## Riley Referral Motion - Key Map and Figure Changes

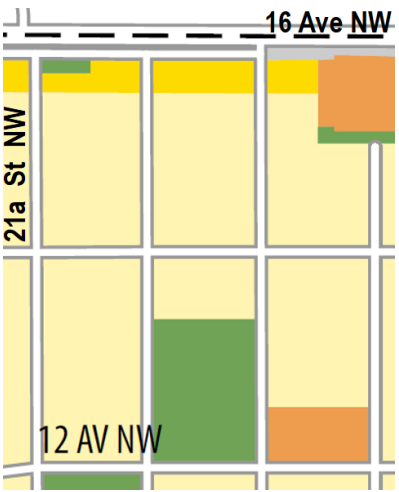
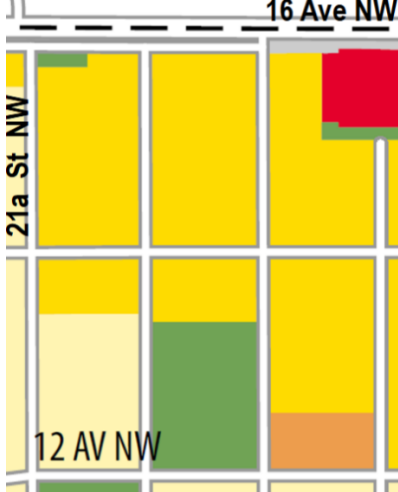
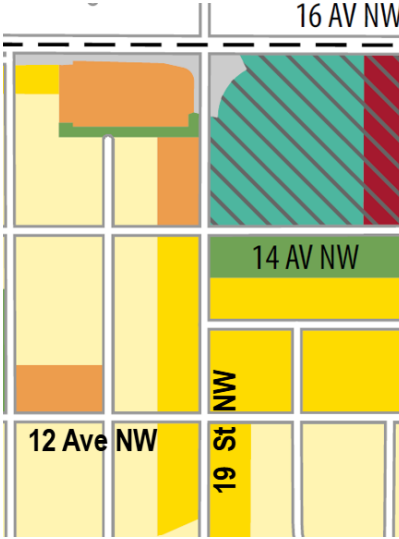
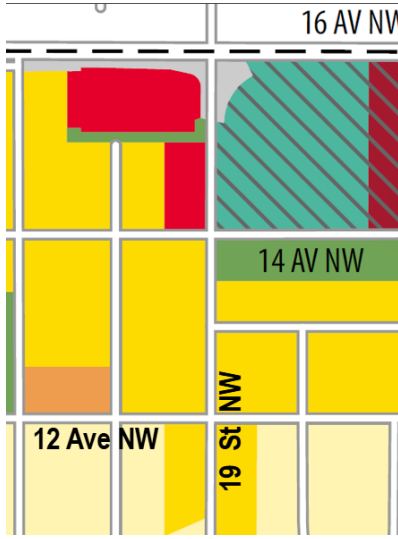
October 2024 IPC Version	January 2025 IPC Version	Plan Map/Figure	Key Proposed Updates
		<p>Map 3: Urban Form</p>	<p>Update Map 3 to introduce additional Neighbourhood Connector west of Lions Park LRT Transit Station.</p>
		<p>Map 3: Urban Form</p>	<p>Update Map 3 to change previously designated Neighbourhood Flex sites along 16 Avenue NW and 19 Street NW to Neighbourhood Commercial.</p>

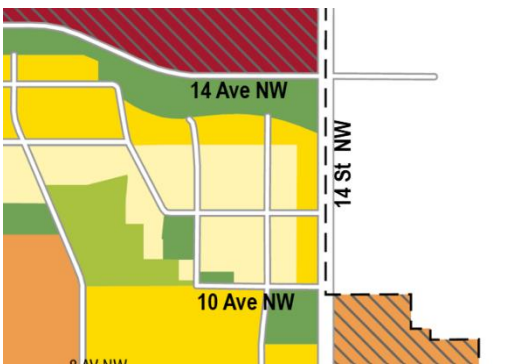
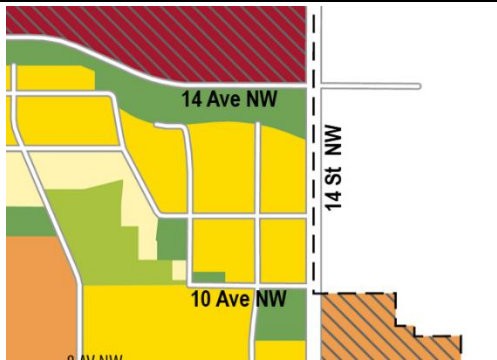
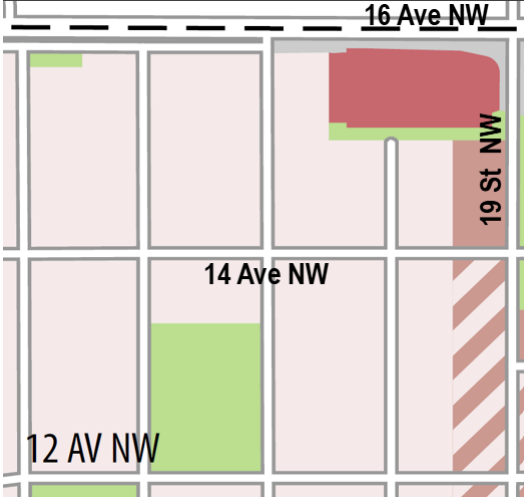
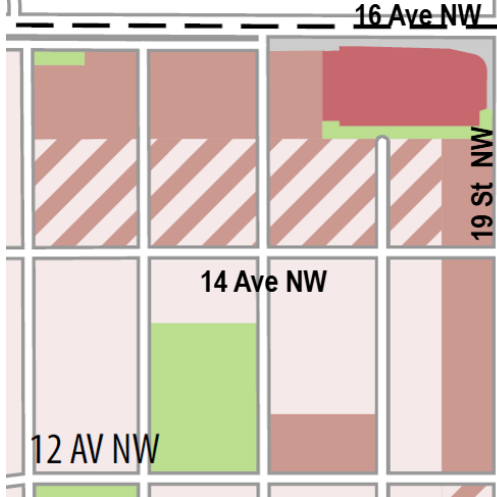
October 2024 IPC Version	January 2025 IPC Version	Plan Map/Figure	Key Proposed Updates
		<p>Map 3: Urban Form</p>	<p>Update Map 3 to introduce additional Neighbourhood Connector west of 14 Street NW.</p>
		<p>Map 4: Building Scale</p>	<p>Update Map 4 to introduce additional Low – Modified (up to 4 storeys) and Low (up to 6 storeys) around the Lions Park Station area west of 19 Street NW along 16 Avenue NW, south along 19 Street and on an existing commercial site along 12 Avenue NW.</p>

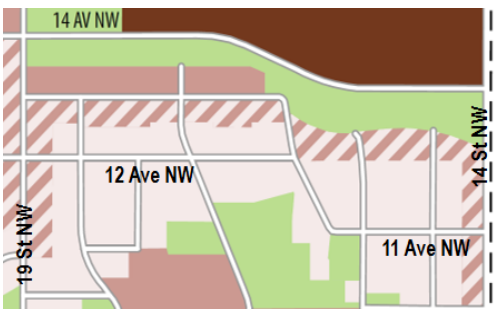
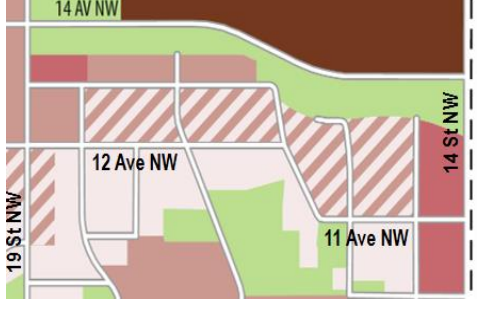
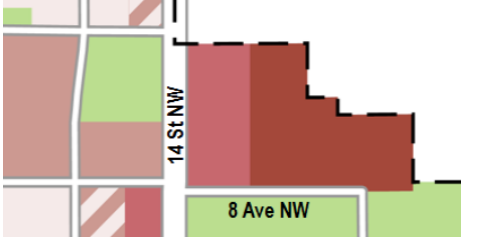
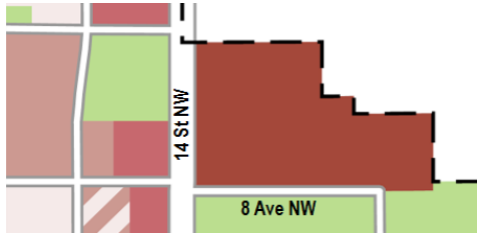
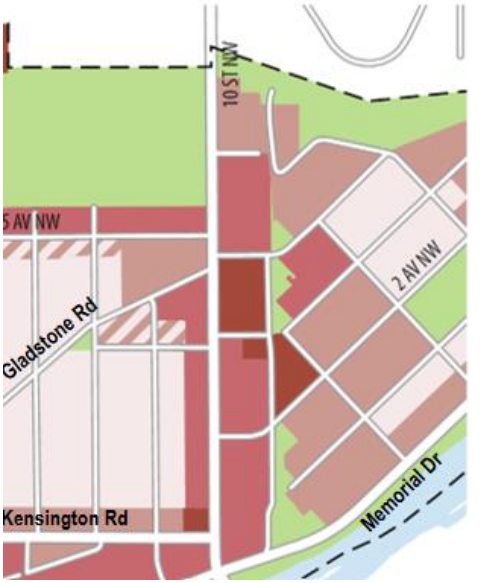
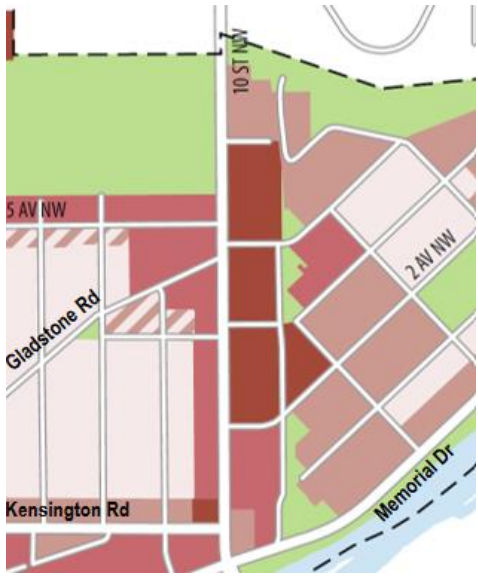
October 2024 IPC Version	January 2025 IPC Version	Plan Map/Figure	Key Proposed Updates
		<p>Map 4: Building Scale</p>	<p>Update Map 4 to introduce additional Low (up to 6 storeys) and Mid (up to 12 storeys) east of 19 Street NW, and additional Low – Modified (up to 4 storeys) along the north side of 12 Avenue NW and 11 Avenue NW. Change two blocks along the west side of 14 Street NW to Mid (up to 12 storeys).</p>
		<p>Map 4: Building Scale</p>	<p>Update Map 4 to include additional Mid (up to 12 storeys) at the northwest corner of 14 Street NW and 8 Avenue NW, and change the Riley Park Village site to High (up to 26 storeys).</p>
		<p>Map 4: Building Scale</p>	<p>Update Map 4 to introduce additional Mid (up to 12 storeys) west of 10 Street NW along Gladstone Road. Height modifiers were removed resulting in up to 26 storeys being proposed on the Safeway and triangle sites. Parcels to the north and south of the Safeway site are now a modified scale of up to 15 storeys. The remainder of 10 Street NW to the south transitions to 12 storeys and then down to up to 6 storeys for sites at the northwest corner of 10 Street NW and Memorial Drive NW.</p>

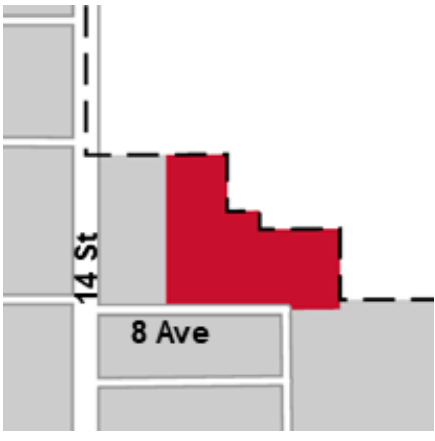
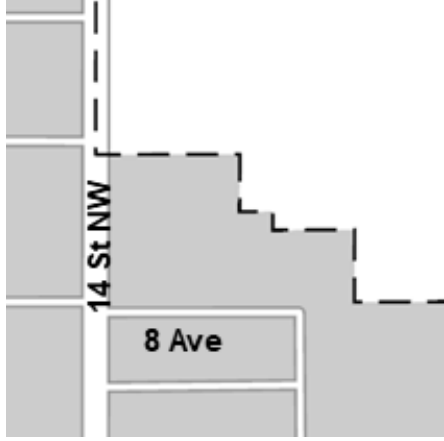
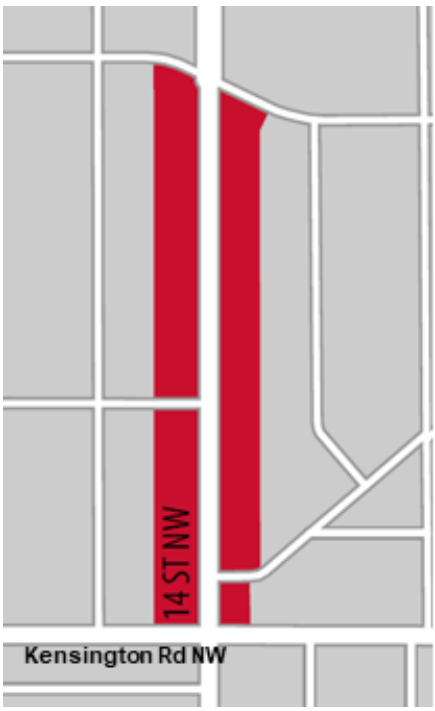
October 2024 IPC Version	January 2025 IPC Version	Plan Map/Figure	Key Proposed Updates
		<p>Figure 4: Modified Building Scale Areas</p>	<p>Update Figure 4 to remove Modified Building Scales from the Riley Park Village site. The entire site now allows up to 26 storeys.</p>
		<p>Figure 4: Modified Building Scale Areas</p>	<p>Update Figure 4 to remove Modified Building Scales from sites along 14 Street NW to now allow for up to 12 storeys.</p>

October 2024 IPC Version	January 2025 IPC Version	Plan Map/Figure	Key Proposed Updates
		<p>Figure 4: Modified Building Scale Areas</p>	<p>Update Figure 4 to remove Modified Building Scales on the Safeway site and the triangle site to now allow for up to 26 storeys.</p> <p>Introduce Modified Building Scales east of 10 Street NW on the blocks directly north and south of the existing Safeway site, which will be limited up to 15 storeys.</p> <p>Maintain Modified Building Scale on the site located at the northeast corner of 10 Street NW and Kensington Road NW, limited up to 16 storeys.</p>
		<p>Figure 11: Lions Park LRT Transit Station Area</p>	<p>Update Figure 11 to introduce additional Core Zones around the Lions Park LRT Transit Station along 19 Street NW and 13 Avenue NW.</p> <p>Introduce additional Transition Zones west of 19 Street NW and south 12 Avenue NW on the east side of Lions Park.</p>

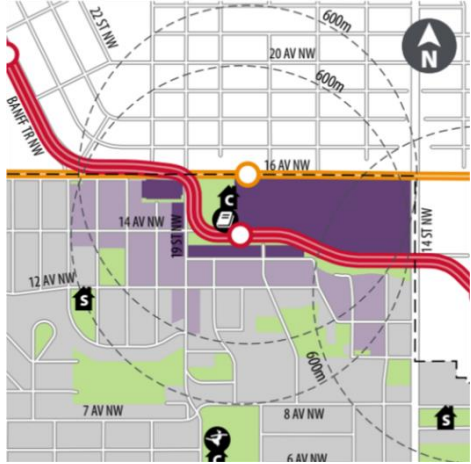
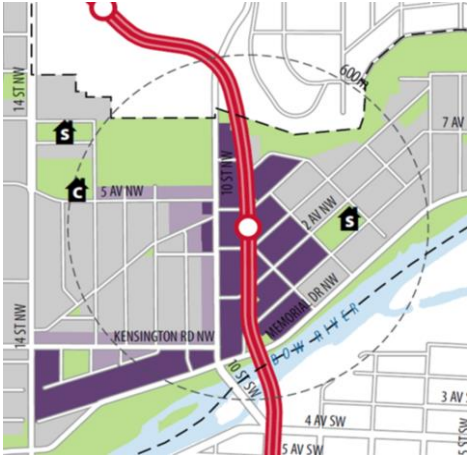
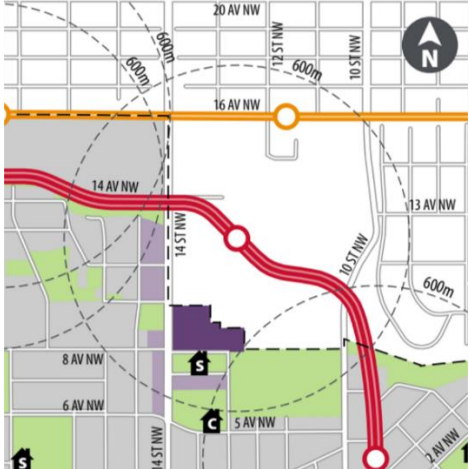
October 2024 IPC Version	January 2025 IPC Version	Plan Map/Figure	Key Proposed Updates
		<p>Figure 12: Sunnyside LRT Transit Station Area</p>	<p>Update Figure 12 to introduce additional Core Zones west of 10 Street NW.</p> <p>Introduce additional Transition Zones west of 10 Street NW along 5 Avenue NW and Gladstone Road NW, and eastbound along Memorial Drive NW.</p> <p>Change Core Zones west of 10 Street NW along Kensington Road NW and Memorial Drive NW to Transition Zones.</p>
<p><i>*not included in October 2024 IPC proposed Plan</i></p>		<p>Figure 15: SAIT / AUArts / Jubilee LRT Transit Station Area</p>	<p>Include Figure 15 for the SAIT / AUArts / Jubilee LRT Transit Station Area, which lists the Riley Park Village site as a Core Zone and includes Transition Zones along 14 Street NW and along south side of 7 Avenue NW.</p>
